October 1, 2020

Historic District Review Commission

Re: Dawson at N. Olive Project

Below is the response to Staff's comments as per their document received on September 11, 2020.

SHEET TITLE  
**OVERALL FLOOR  
PLANS - LEVEL 01, &  
02**

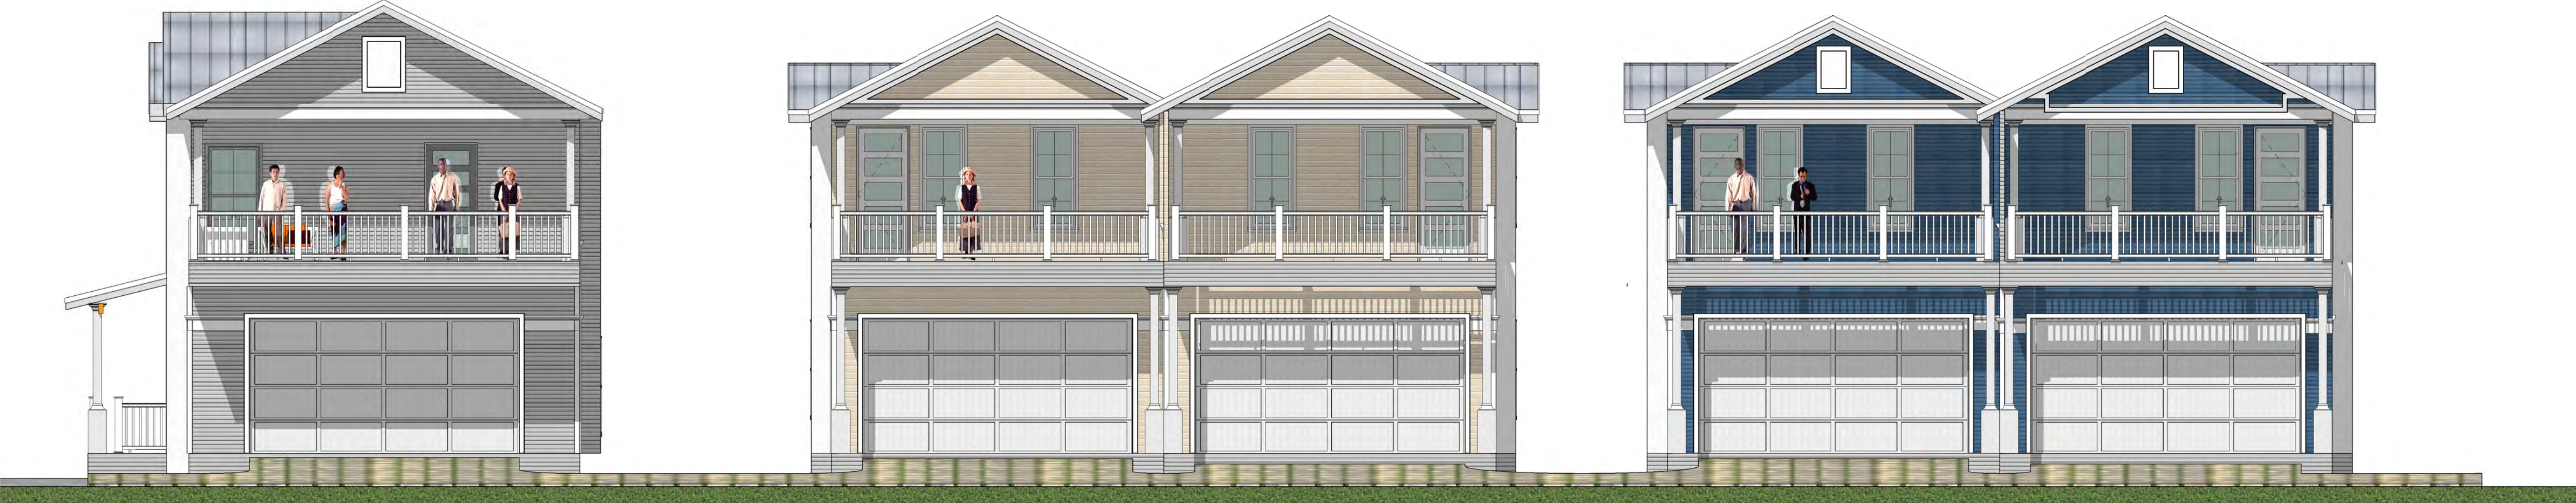
l. BUILDING SPACING – The applicant has proposed approximately thirteen (13) and seven (7) feet between each structure. The proposed building spacing is atypical for what is found historically within the district.

- vi. That the proposed building spacing be increased as noted in finding l.

**RESPONSE:** building spacing has been increased to sixteen (16'-6") feet and nine (9) feet. See the revised site plan.

**RESPONSE:** Please refer to the revised site plan. The plan shows that the building spacing has been increased
